Addendum to the
Environmental Impact
Assessment Report

NISA
North Irish Sea Array

Appendix A17.2

Vessel Management Plan

Figure A7.1 Anchorage Areas (replaces Figure 7.1 of Appendix 17.3 Vessel Management Plan of the 2024 EIAR)

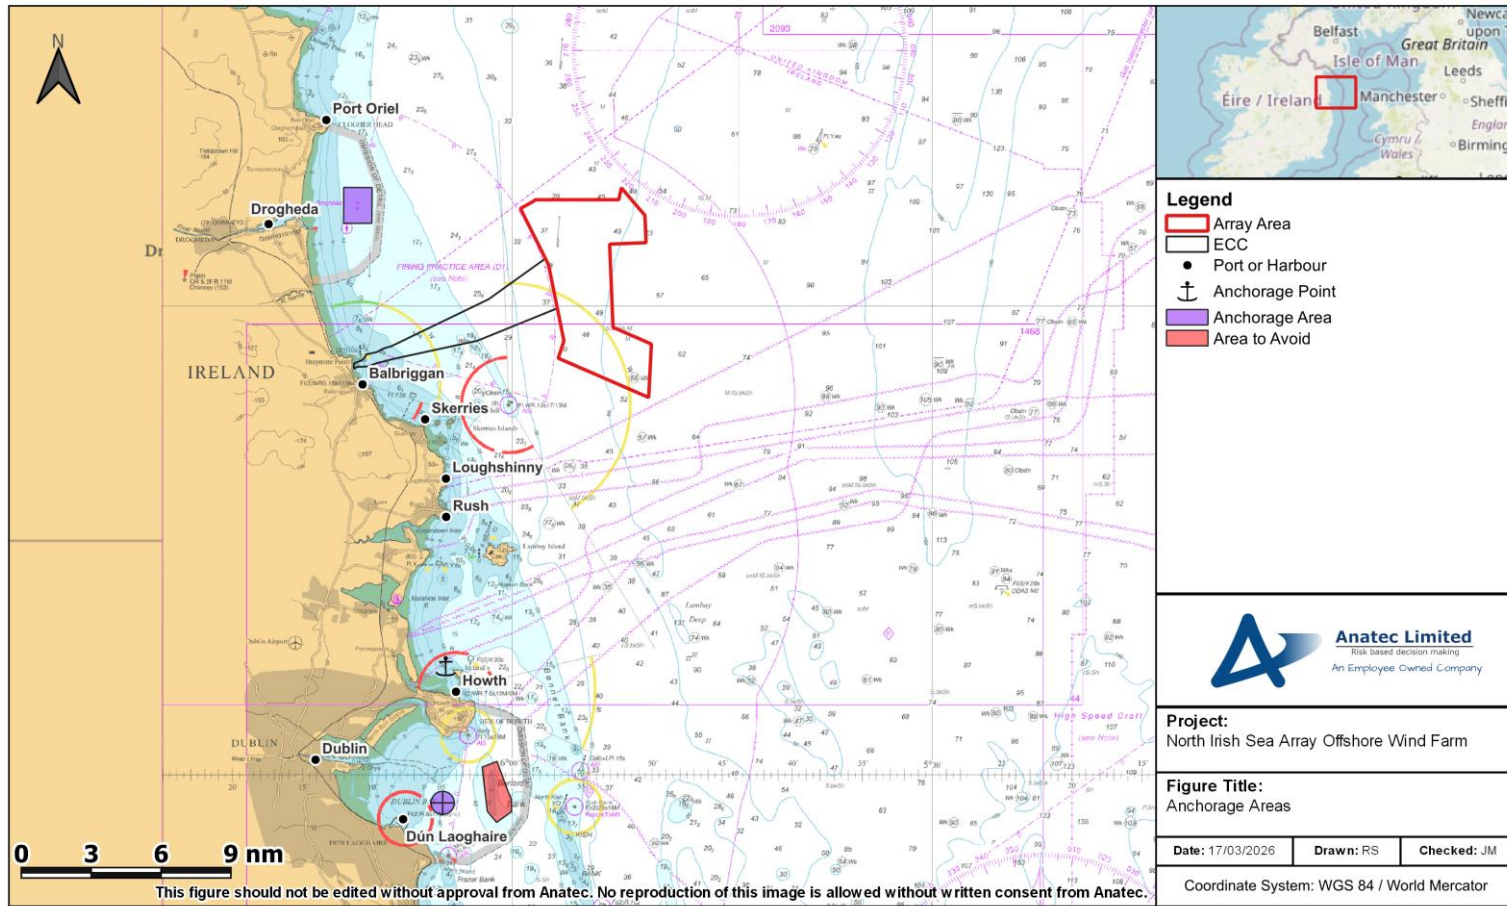
35. **United Kingdom Hydrographic Office (UKHO) Admiralty Charts have been updated since the submission of the 2024 EIAR and so navigational features have been reviewed to account for any potential updates. This is to satisfy RFI1 (b), which states the scientific information provided should be based on up-to-date survey reports and data. Although no new anchorage areas have been identified, other charted navigational features have been updated and therefore Figure 7.1 referenced in Section 7.1.2 of Appendix 17.3: Vessel Management Plan of the 2024 EIAR has been replaced with Figure A7.1.**
